TPWD Headquarters EO- ADA Evaluation

TPWD- Austin TX, HQ & Parking ADA Evaluation

Accessibility Evaluation

Inspection Date: 07/01/2020

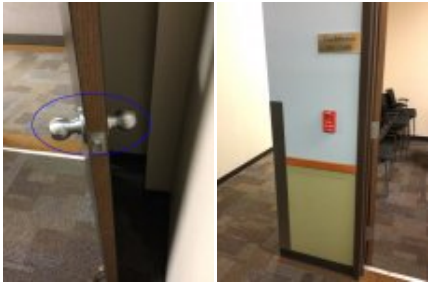
Finding Number	Area Description	Finding	As Built	Recommendation	Citation	Photos	Figure
96	First Floor, Building C100 (STAFF): Restrooms and water fountains (C100) - Women's restroom	The water closet compartment is missing a loop handle on one side or both sides of the door. Water closet compartments must be equipped with a door that has a loop or U-shaped handle on both sides of the door near the latch. The latch must be flip-over style, sliding or other hardware not requiring the user to grasp or twist.	missing	https://www.access-board.gov/ada/#ada-604_8_1_2	2012 TAS Section: 604.8.1.2 2010 ADAS Section: 604.8.1.2 2015 ABAAS Section: 604.8.1.2	 	
97	First Floor, Building C100 (STAFF): Restrooms and water fountains (C100) - Water Fountain	The drinking fountain is not accessible. The water fountains spread throughout C100 are not accessible due to a number of factors. **The C100 water refill stations are compliant. . Drinking fountains must be on an accessible route. An accessible route of travel is 36 inches wide minimum and provides a 30 inch by 48 inch clear floor space centered on the unit that allows a forward approach to the drinking fountain. At "hi-low" type fountains, the centerline of the 30 inch by 48 inch clear floor space must be centered on the "low" fountain. Spout outlets of drinking fountains for standing persons shall be 38 inches minimum and 43 inches maximum above the finish floor or ground. All drinking fountains shall be located completely within alcoves, positioned completely between wing walls, or otherwise positioned so as not to encroach into pedestrian ways. An alcove must not be less than 32 inches in width and 18 inches in depth. Wing walls must project out from the supporting wall at least as far as the drinking fountain.	Water fountain has been removed and water refill stations meet compliance.	Staff or public can use the water refill station located in building C100. Staff can use public water fountains located in building B100 as those are ADA compliant. These water fountains would need to be updated in order to be compliant.	2012 TAS Section: 403.5.1, 602.1 2010 ADAS Section: 403.5.1, 602.1 2015 ABAAS Section: 403.5.1, 602.1

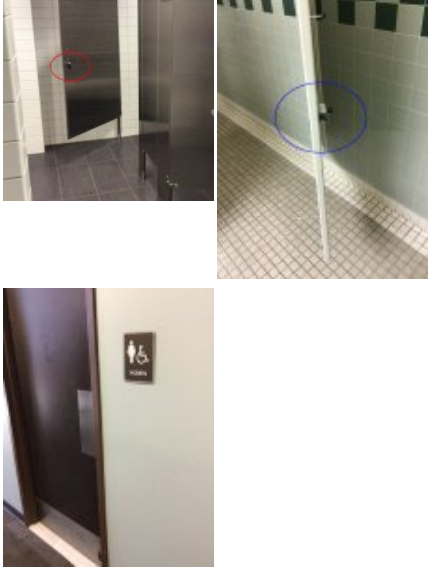
Finding Number	Area Description	Finding	As Built	Recommendation	Citation	Photos	Figure
107	First Floor, Building C100 (STAFF): Interior spaces (C100) - Conference Room C100	The light switch is positioned too high for either a side or front approach. Where a clear floor or ground space allows a parallel approach to an element and the side reach is unobstructed, the high side reach shall be 48 inches maximum and the low side reach shall be 15 inches minimum above the finish floor or ground. Where a forward reach is unobstructed, the high forward reach shall be 48 inches maximum and the low forward reach shall be 15 inches minimum above the finish floor or ground.	measures over 48"		https://www.access-board.gov/ada/#ada-308_1 2012 TAS Section: 308.1 2010 ADAS Section: 308.1 2015 ABAAS Section: 308.1		
108	First Floor, Building C100 (STAFF): Interior spaces (C100) - Conference Room C100	The room identification sign is noncompliant. Wall signs identifying permanent rooms and spaces of a building shall be in a horizontal format and the characters raised 1/32 inch minimum and shall be sans serif uppercase characters a minimum of 5/8 inch and a maximum of 2 inches high. Characters and their background shall have a non-glare finish. Characters shall contrast with their background with either light characters on a dark background or dark characters on a light background. Signs with raised characters or Braille shall be located 48 inches minimum above the finish floor or ground surface, measured from the baseline of the lowest tactile character and 60 inches maximum above the finish floor or ground surface, measured from the baseline of the highest tactile character.	Signs that identify a room, space or area are required to have raised characters and Braille. This requirement includes both public access areas as well as all employee areas.	Wall sign designation https://www.access-board.gov/ada/#ada-216_2 Wall signs general https://www.access-board.gov/ada/#ada-703_1	2012 TAS Section: 216.2, 703.1 2010 ADAS Section: 216.2, 703.1 2015 ABAAS Section: F216.2, 703.1

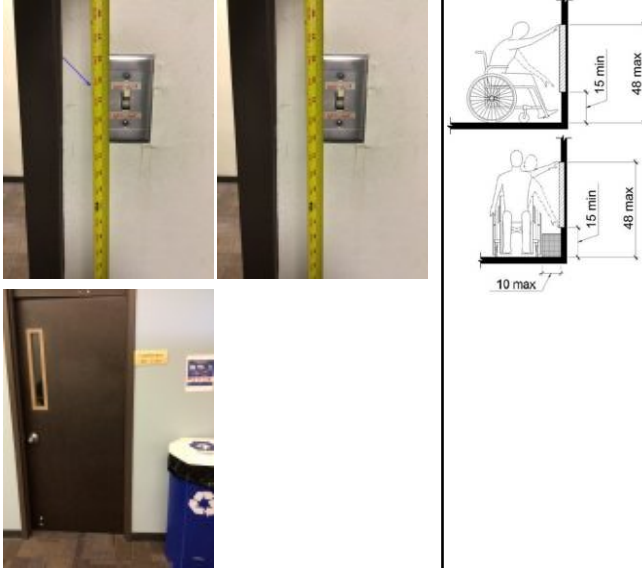
Finding Number	Area Description	Finding	As Built	Recommendation	Citation	Photos	Figure
118	Second Floor, Building C200 (STAFF) : Restrooms and water fountains (C200) - Men's restroom	The water closet compartment is missing a loop handle on one side or both sides of the door. Water closet compartments must be equipped with a door that has a loop or U-shaped handle on both sides of the door immediately below the latch. The latch must be flip-over style, sliding or other hardware not requiring the user to grasp or twist.	N/A	https://www.access-board.gov/ada/#ada-604_8_1_2	2012 TAS Section: 604.8.1.2 2010 ADAS Section: 604.8.1.2 2015 ABAAS Section: 604.8.1.2		
119	Second Floor, Building C200 (STAFF) : Restrooms and water fountains (C200) - Men's restroom	The threshold has a vertical change greater than 1/4 inch. The threshold at a doorway shall be no higher than 1/2 inch. Changes in level between 1/4 inch and 1/2 inch must be beveled at 1:2 or less. The maximum vertical rise shall be 1/4 inch.	N/A	https://www.access-board.gov/ada/#ada-404_2_5	2012 TAS Section: 404.2.5 2010 ADAS Section: 404.2.5 2015 ABAAS Section: 404.2.5

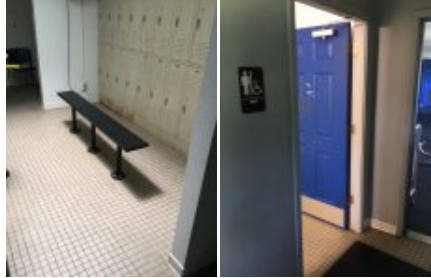
131	Exterior of Property Gym (STAFF) : Parking Lot (Gym) - Path of Travel to Gym	The accessible route contains loose gravel and/or surface materials that do not provide for a stable, firm slip resistant surface. Side walk leading to gym in good condition. Currently access route to gym from exterior to interior of building is compliant. This will need to be maintained regularly or updated to ensure long term compliance.	Parking lot and parts of pathway leading to gym are not compliant due to loose terrain and overgrowth	https://www.access-board.gov/ada/#ada-302_1	2012 TAS Section: 302.1 2010 ADAS Section: 302.1 2015 ABAAS Section: 302.1

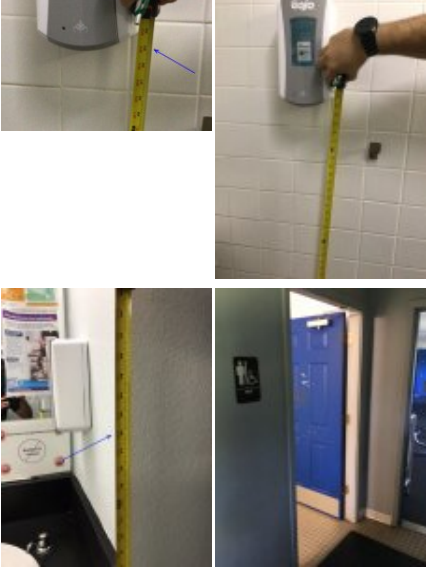
Finding Number	Area Description	Finding	As Built	Recommendation	Citation	Photos	Figure
132	First Floor, Gym (STAFF) : Building Entrance - Gym entry doors (from parking lot)	The right door is compliant, the left door is not. There are no handles on either side of left door. Door can only be opened by internal latches that are not accessible. The operating hardware requires tight grasping, pinching or twisting of the wrist to operate. Hand-activated hardware, handles, pulls, latches, locks, and other operating devices on accessible elements shall have a shape that is easy to grasp with one hand and does not require tight grasping, pinching or twisting of the wrist to operate.	double door (pictured) opening/locking mechanism is not compliant.	Make right side entrance door fully accessible or add accessible door mechanisms including handles, and entrance requirements to left door. https://www.access-board.gov/ada/#ada-309_4	2012 TAS Section: 309.4 2010 ADAS Section: 309.4 2015 ABAAS Section: 309.4

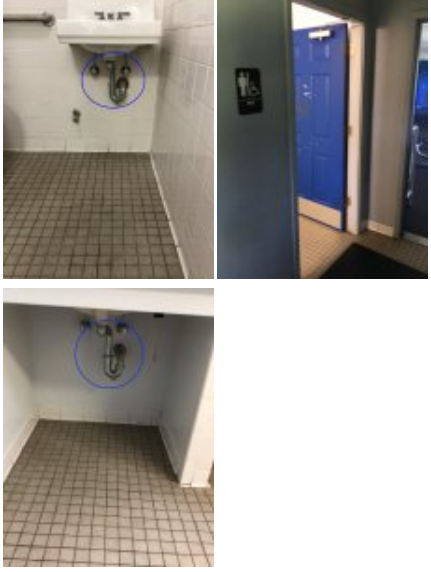
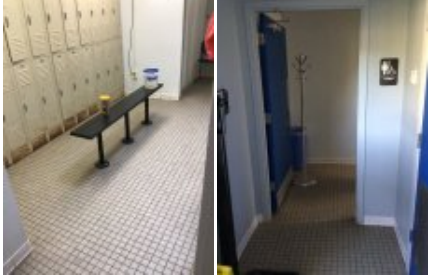
Finding Number	Area Description	Finding	As Built	Recommendation	Citation	Photos	Figure	
135	First Floor, Gym (STAFF) : Building Entrance - Entry door into gym space	The door exceeds the maximum allowable opening force. The entrance door used to gain access to workout/weight room area. Interior doors shall have a maximum opening force of 5 pounds. These forces do not apply to the force required to retract latch bolts or disengage other devices that hold the door or gate in a closed position.	exceeds 5lbs force		https://www.access-board.gov/ada/#ada-404_2_9	2012 TAS Section: 404.2.9 2010 ADAS Section: 404.2.9 2015 ABAAS Section: 404.2.9		
136	First Floor, Gym (STAFF) : Dressing Rooms and Water Fountains - Men's Dressing Room	The bench is not affixed to a wall or provides back support. The bench shall provide for back support or shall be affixed to a wall along its long dimension. Back support shall be 42 inches long minimum and shall extend from a point 2 inches maximum above the seat surface to a point 18 inches minimum above the seat surface. Back support shall be 2 -1/2 inches maximum from the rear edge of the seat measured horizontally.	locker room benches are required to have back support		https://www.access-board.gov/ada/#ada-903_4	2012 TAS Section: 903.4 2010 ADAS Section: 903.4 2015 ABAAS Section: 903.4

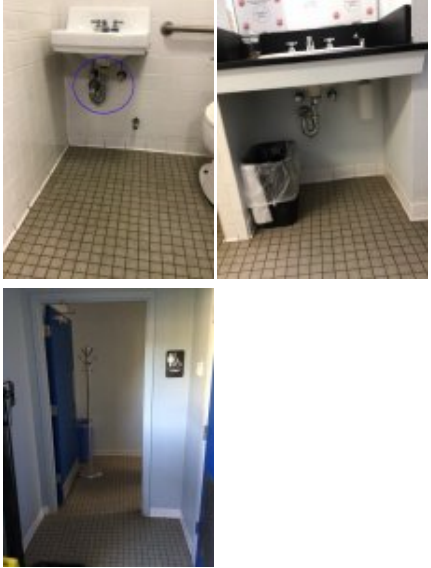
Finding Number	Area Description	Finding	As Built	Recommendation	Citation	Photos	Figure	
141	First Floor, Gym (STAFF) : Dressing Rooms and Water Fountains - Men's Dressing Room	The water and drain pipes under the lavatory are not adequately insulated. ** Both sinks in men's restroom. Water supply and drain pipes under lavatories and sinks shall be insulated or otherwise configured to protect against contact. There shall be no sharp or abrasive surfaces under lavatories and sinks.	pipes are exposed for both sinks provided.		https://www.access-board.gov/ada/#ada-606_5	2012 TAS Section: 606.5 2010 ADAS Section: 606.5 2015 ABAAS Section: 606.5		
142	First Floor, Gym (STAFF) : Dressing Rooms and Water Fountains - Men's Dressing Room	The lavatory is located in a toilet compartment. Accessible lavatories shall not be located in toilet compartments.	N/A		https://www.access-board.gov/ada/#ada-213_3_4	2012 TAS Section: 213.3.4 2010 ADAS Section: 213.3.4 2015 ABAAS Section: F213.3.4
